Regulatory Submission for period 2021/22 to 2025/26

UNITED ENERGY - REVIEW OF ASPECTS OF PROPOSED EXPENDITURE

Report prepared for:
**AUSTRALIAN ENERGY
REGULATOR**
August 2020

Figure 5.3: DC substation maximum demand forecast (10% PoE, MW) prior to stage 1 feeder implementation

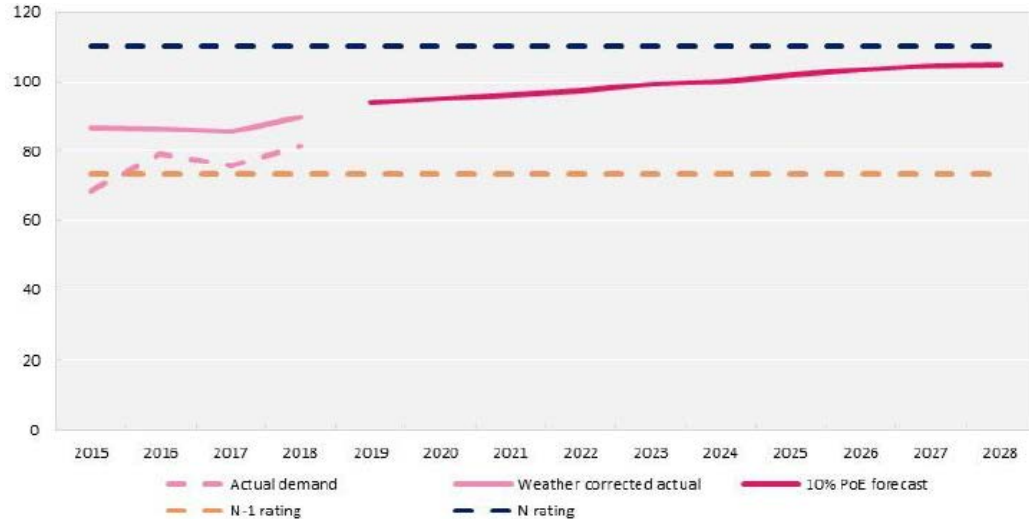
489. United Energy's 10% PoE demand forecast for DC substation is shown in the figure below. Growth in peak demand is forecast to be 1.3% over the next 7-10 years. Figure 5.3 is from United Energy's business case and shows that the peak demand is well above the N-1 cyclic rating¹⁴⁸ (or 'N-1 capacity') and is trending towards the N cyclic rating.¹⁴⁹ United

Figure 5.7: Malvern substation maximum demand forecast (10% PoE, MW)

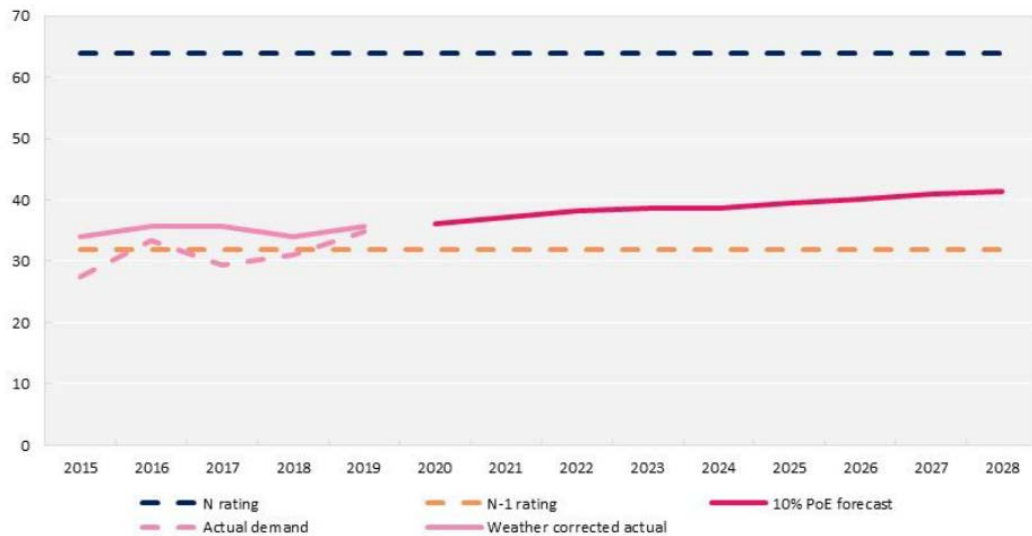
527. United Energy’s 10% PoE forecast for EM substation is shown in the figure below. Growth in maximum demand is forecast to be 1.8% over the next 7-10 years. The forecast peak demand growth at CFD and K substations is 1.3% and 1.7%, respectively.
528. Figure 5.7 is from United Energy’s business case and shows that the peak demand is above the N-1 cyclic rating¹⁶⁴ (or ‘N-1 capacity’). The 10% PoE peak demand at CFD and K

Figure 5.12: Keysborough supply area feeder utilisation forecast (10%PoE)

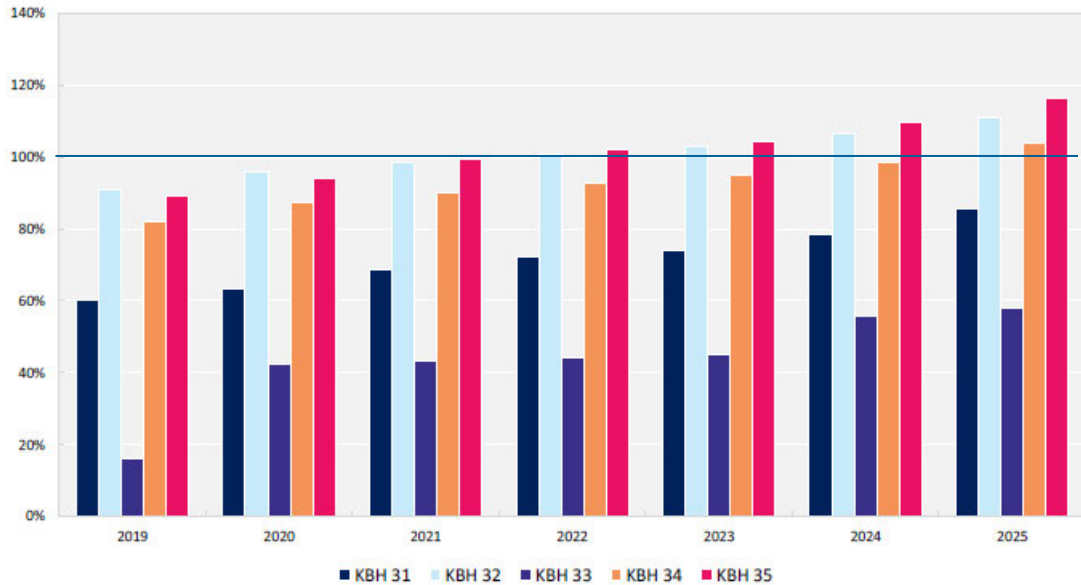
562. As shown in the figure below, United Energy forecasts that several feeders at KBH substation will exceed, or come close to exceeding, their respective utilisation ratings in the next RCP.
563. From the KBH substation load duration curve presented as Figure 7 in the business case, approximately 15% of the peak demand experienced is 2% (175 hrs) per year. This means that at peak times, the high utilisation of a large number of feeders could be operationally problematic, but the amount of time that the feeders exceed 90% loading could be much less than 2% per year.
564. If United Energy had presented the feeder utilisation forecasts based on 50%PoE demand, which, by definition, is the median of the outcomes, the graph may have shown that feeder utilisations do not exceed 100% by the end of the next RCP (or if they do it would be by a

Figure 6.5: Cumulative NPV of the proposed 319 LV augmentations proposed by CitiPower, over different analysis horizons - \$millions

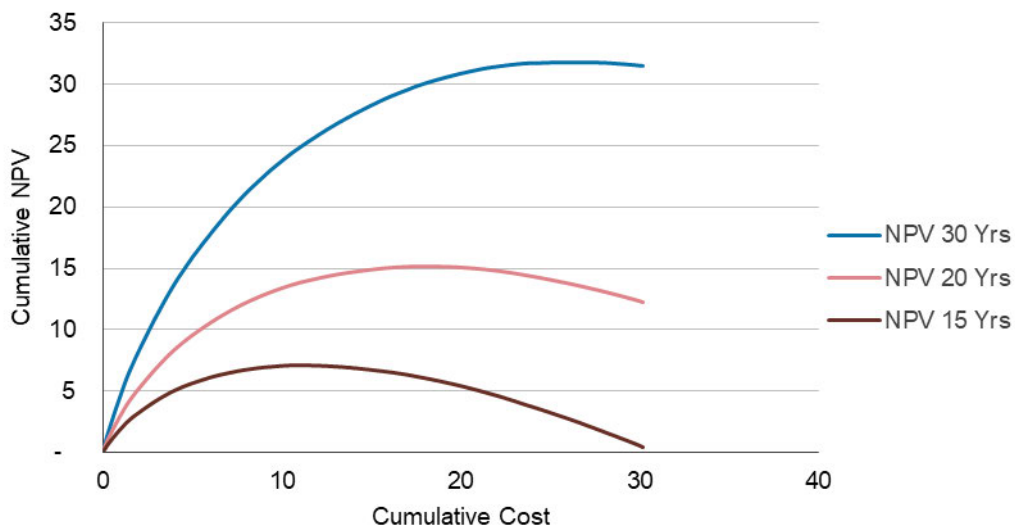
733. To provide an indication of sensitivity, we show in Figure 6.5 below an equivalent sensitivity analysis for CitiPower, where we tested for sensitivity of CitiPower’s result to the time period considered. The lower two lines in Figure 6.5 show the implication of adopting 20-year and 15-year horizons respectively, for the NPV analysis. With analysis over only 15 years, on the plausible assumption that forecasting beyond that time is too uncertain, only around one-third of the proposed augmentations would have a positive NPV. The remainder of the augmentations would have a negative NPV. In aggregate, if all of the upgrades were done, the NPV of the program would be effectively zero.

752. As we have shown in Figure 6.5, when we consider shorter analysis periods, it appears by analogy with the modelling undertaken for CitiPower that a large number of the proposed augmentations are likely to have a negative NPV. We also do not accept the proposition that uncertainty is accounted for by United Energy adopting conservative assumptions. Even if conservative assumptions have been adopted, there is a range of techniques available for modelling such analysis under uncertainty, with sensitivity analysis and scenario analysis being two of the more basic techniques that can be applied.

Figure 6.6: Annuitised cost and modelled benefits for one of United Energy’s proposed transformer upgrades²⁴⁷

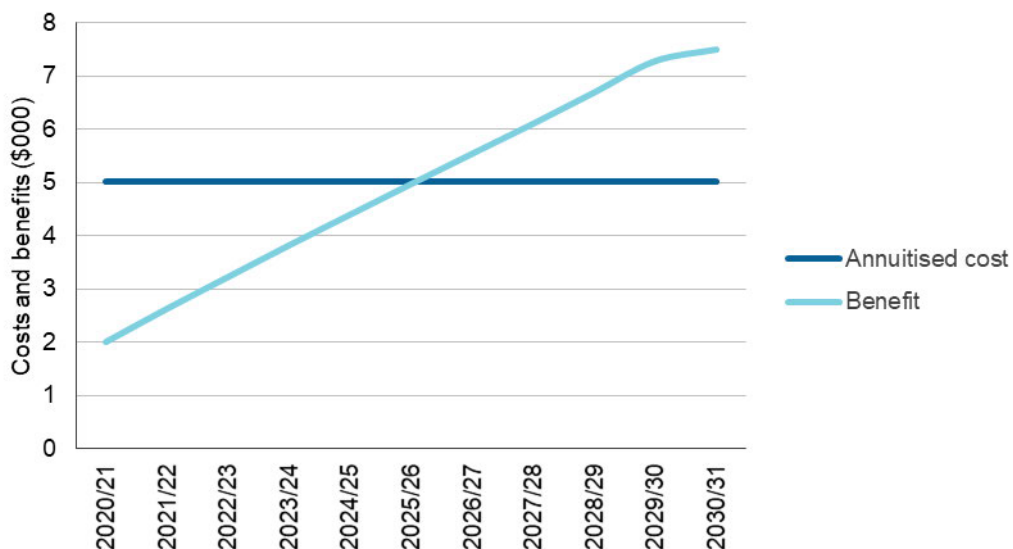
755. In Figure 6.6 we show an example of this methodology applied to a specific LV transformer from United Energy’s solar enablement analysis. In this case, it indicates that an upgrade would be warranted in 2024/25 based on United Energy’s benefit assumptions including its forecast PV uptake rate for customers connected to that transformer.

Figure 6.7: Augmentation profile indicated by identifying year when benefits exceed costs

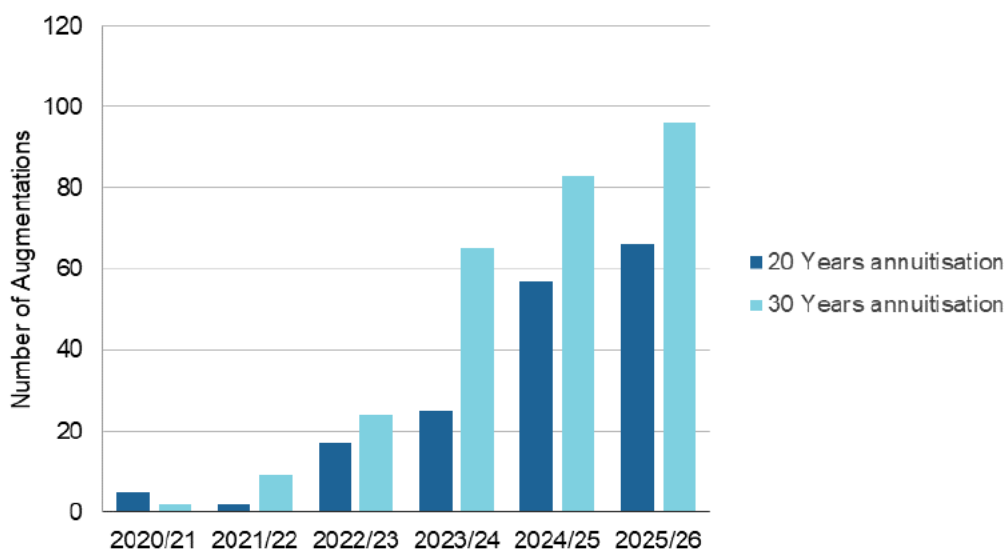
756. When we apply this method to all 533 of United Energy’s proposed augmentations, we find a profile of augmentations as shown in Figure 6.7. We have undertaken this analysis with augmentation costs annuitised over 30 years, as per United Energy’s assumptions, and an alternative forecast in which the cost is annuitised over 20 years.

Figure 8.2: NPV analysis for Mornington depot - \$millions

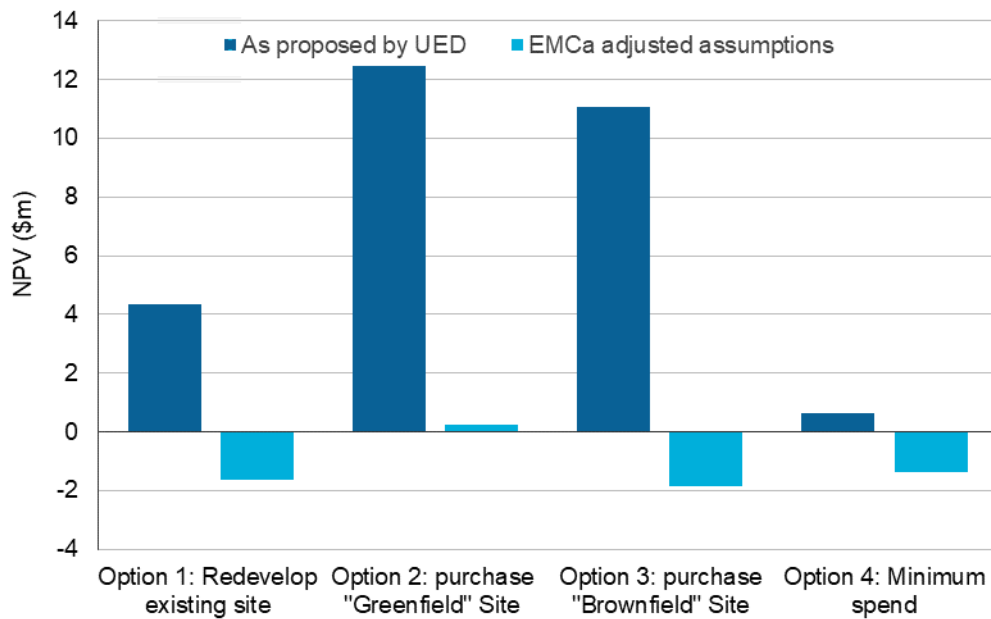
1034. As can be seen in Figure 8.2, our NPV analysis with de-rated benefit assumptions indicates that developing a new depot on a greenfield site in Mornington still has a slightly positive NPV while all other options have a negative NPV. We consider that the proposed expenditure by United Energy for Option 2 is reasonable.

Figure 8.3: NPV analysis for depot at Burwood - \$millions

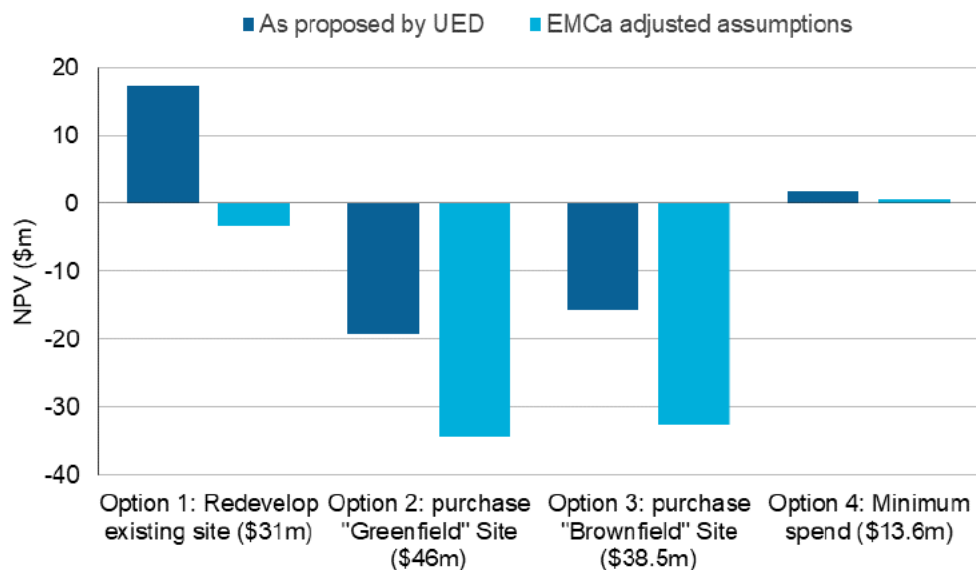
1038. The result in Figure 8.3 shows the NPV of each of the development options relative to the 'do nothing' counterfactual, both under United Energy's assumptions and with our more conservative sensitivity assumptions. It shows that, using de-rated benefit assumptions as described above, all options would have a negative NPV except for the 'Minimum spend' option. Based on the information that United Energy has provided, our assessment therefore indicates concerns with the option that United Energy has proposed to address the issues at this site.

Figure 8.4: NPV analysis for proposed depot at Keysborough - \$millions

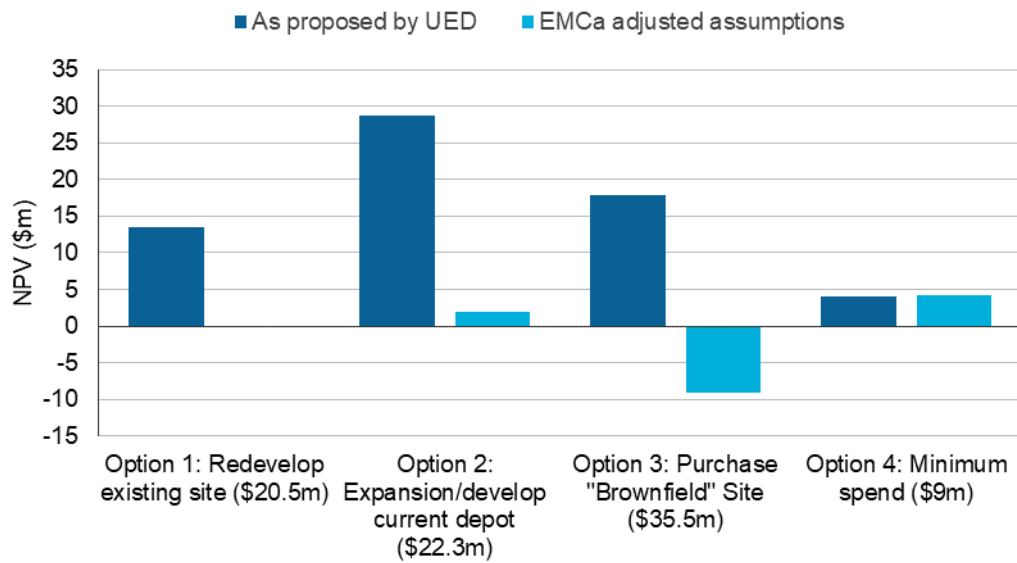
1044. In Figure 8.4 below we show the NPV of each of the upgrade options, relative to the 'do nothing' counterfactual. With more conservative assumptions, the preferred option by United Energy (option 2) has approximately half the NPV of the preferred option (option 4) as determined through our analysis.
